STRUCTURAL SITE INSTRUCTION S-SI# 004

Project Name: Echo Beach (7531 Cove Beach Road)	Project No.: 1633
To: Robin Surcess <robin@westcoastturnkey.com>	Date: 2022 10 06
CC: Eric Pettit <Eric@openspacearchitecture.com>, Erik <Erik@openspacearchitecture.com>	Sheet: 1/2
Subject / Ref. Document: RFI-18 (Masonry Siding Details)

SAMPLE CLADDING TIE SECTION
Scale: N.T.S.

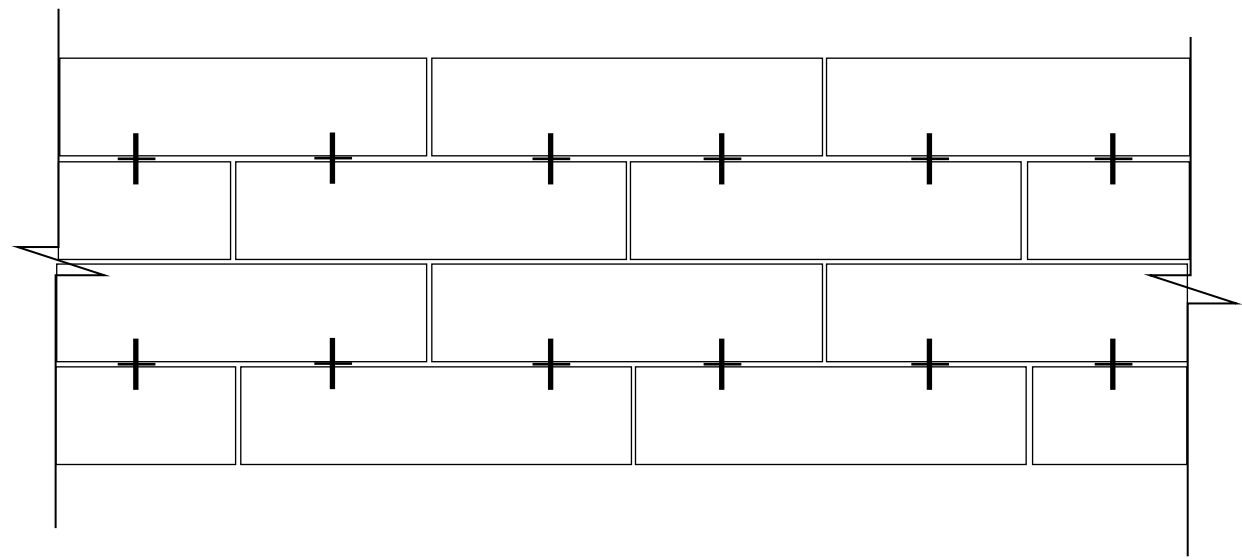
MIN. 8" CONCRETE WALL, SEE PLANS FOR SIZE/REINFORCEMENT

MASONPRO STONE ANCHOR EVERY OTHER BED JOINT, MIN 2 ANCHORS PER STONE

FASTON ANCHOR TO CONCRETE WITH MIN. 3" LONG 1/4" DIAMETER CONCRETE SCREW SUCH AS HILTI KWIC CON II+ OR EQUIVALENT

CONNECTION TO LWF WALL
Scale: N.T.S.

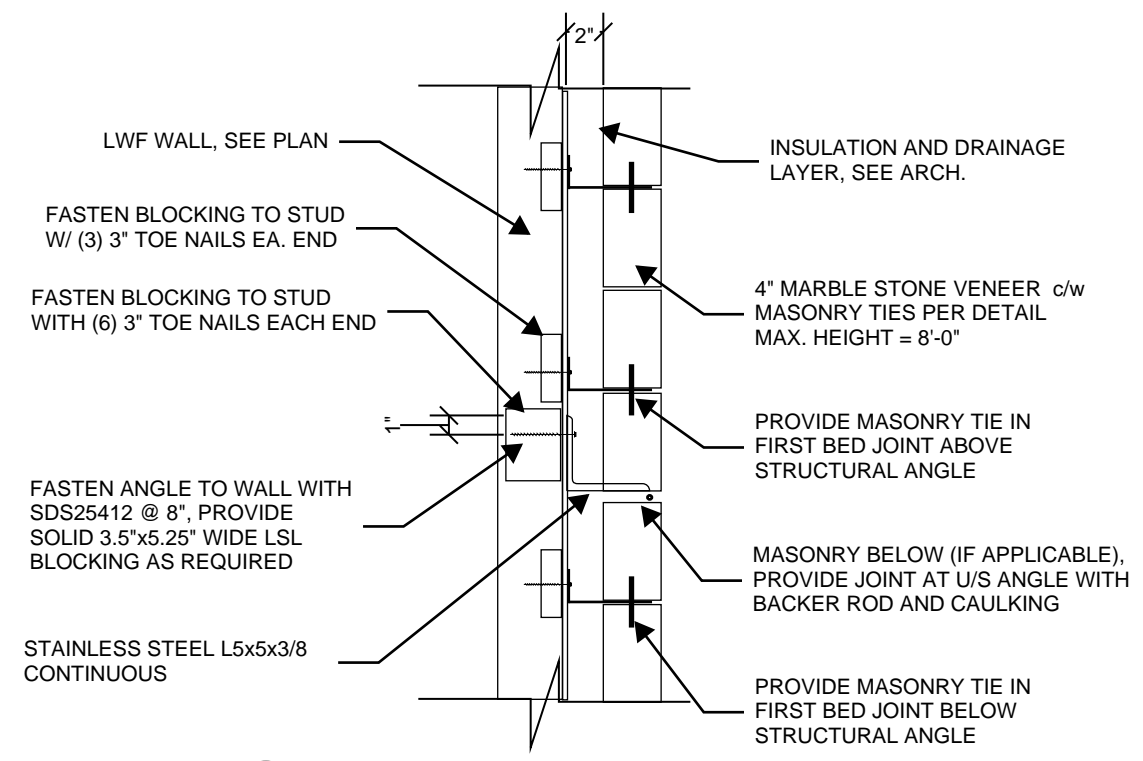
NOTE:
MASONPRO STONE ANCHOR MAY BE SUBSTITUED WITH 1.25" LONG 1/8" THICK 3"x5" BENT PLATE c/w HOLE 1/4" DIAMETER FASTENER AND 3" LONG 3/8" DIAMETER PEG
